**PLANNING AND ZONING COMMISSION
SPECIAL MEETING AGENDA**

Wednesday, October 3, 2018

**Manor City Hall – Council Chambers
105 E. Eggleston Street**

Sheet No. 1 OF 4

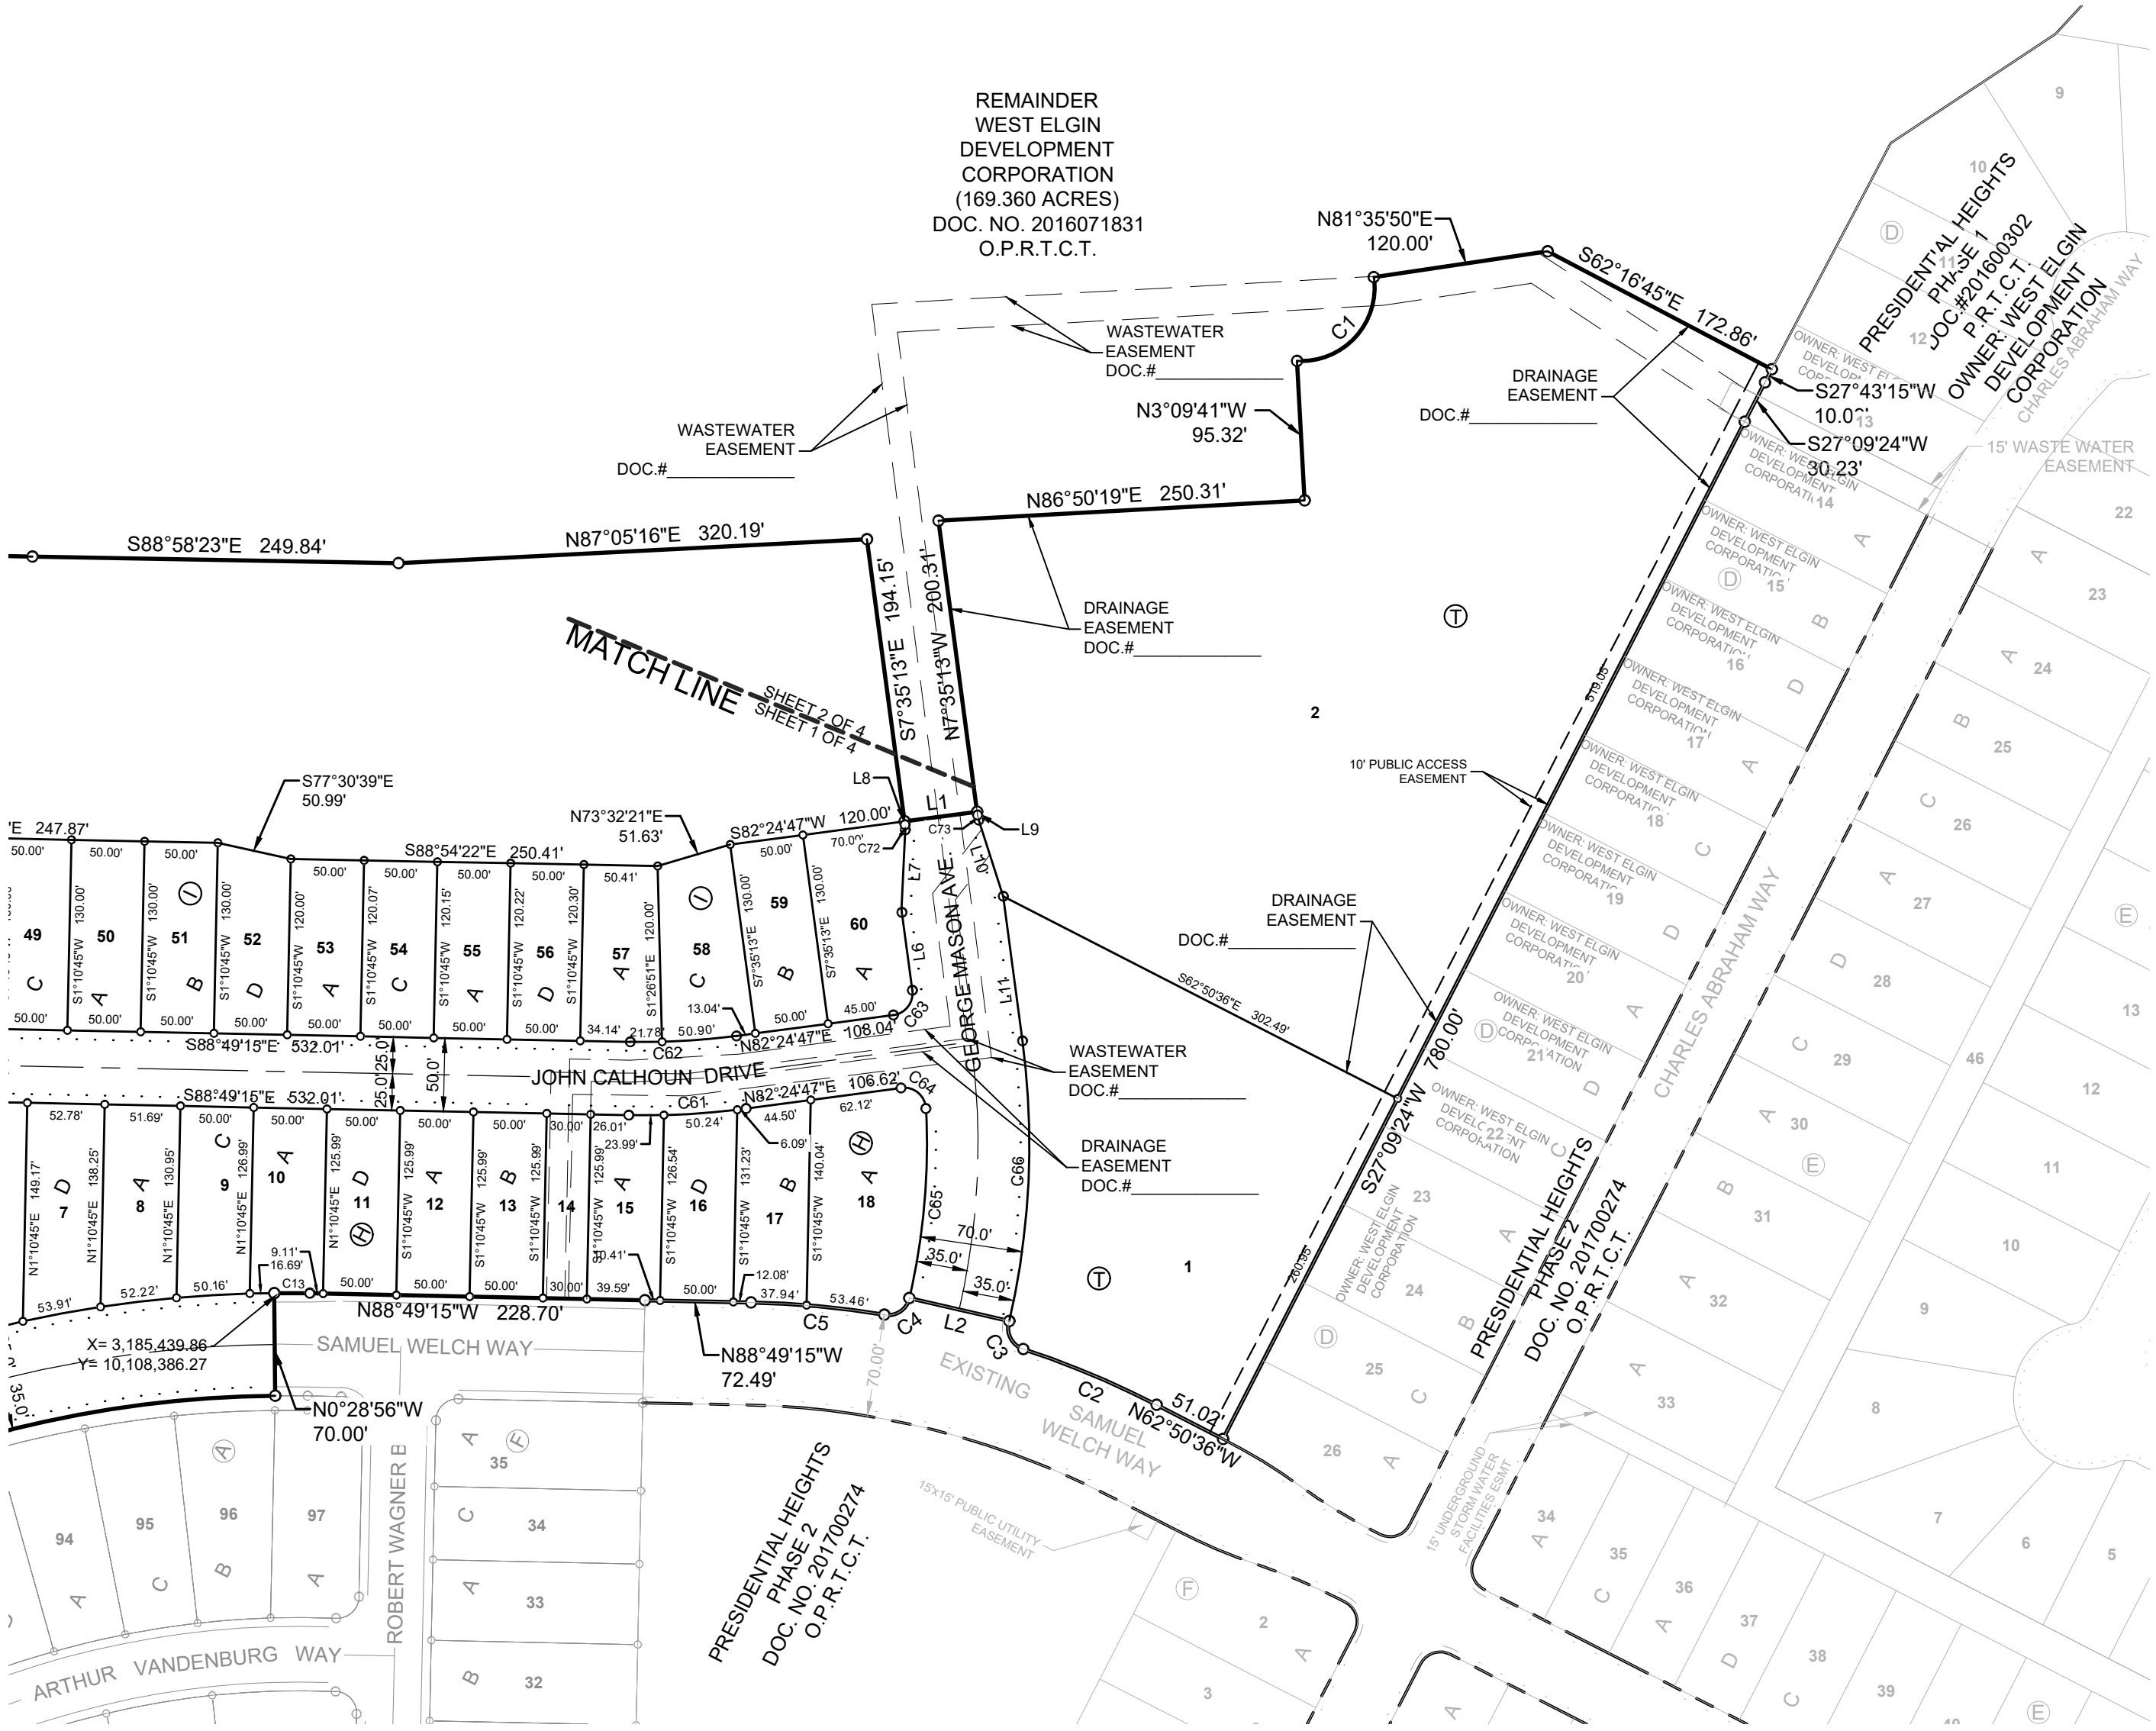
6. Per City of Manor Code of Ordinances Chapter 10, Section 10.02 Exhibit A Subdivision Ordinance 263B Section 24(c)(3)(i), true bearings and distances to the nearest established street lines, official monuments, or existing subdivision corner which shall be accurately described on the plat and rotated to the state plane coordinate system. Using said system, X and Y coordinates shall be identified for four (4) property corners.

16. A note should be added to the plat regarding the two lots that will be conveyed to the City. Note 5 on the final plat for Presidential Heights Phase 2 can be used as a reference.

16. A note should be added to the plat regarding the two lots that will be conveyed to the City. Note 5 on the final plat for Presidential Heights Phase 2 can be used as a reference.

20. A note should be added under the General Notes referencing the conveyance of lots to the City. The note could read as follows:

22. It is unclear to me whether the flag portion of Lot 61 which seems to be about 25' along lots 20-34, Block I is a ROW dedication.

Response: True bearings and distances to the nearest established street lines, official monuments, or existing subdivision corner are accurately described on the plat and rotated to the state plan coordinate system. X and Y coordinates have been identified for four property corners.

Response: Per email correspondence, see note 16 added to the Final Plat.

Response: Per email correspondence, see note 16 added to the Final Plat.

Response: The 25' along lots 20-34 is not a part of ROW dedication. It is a part of lot 61, Block I and is used for drainage purposes and a drainage swale.
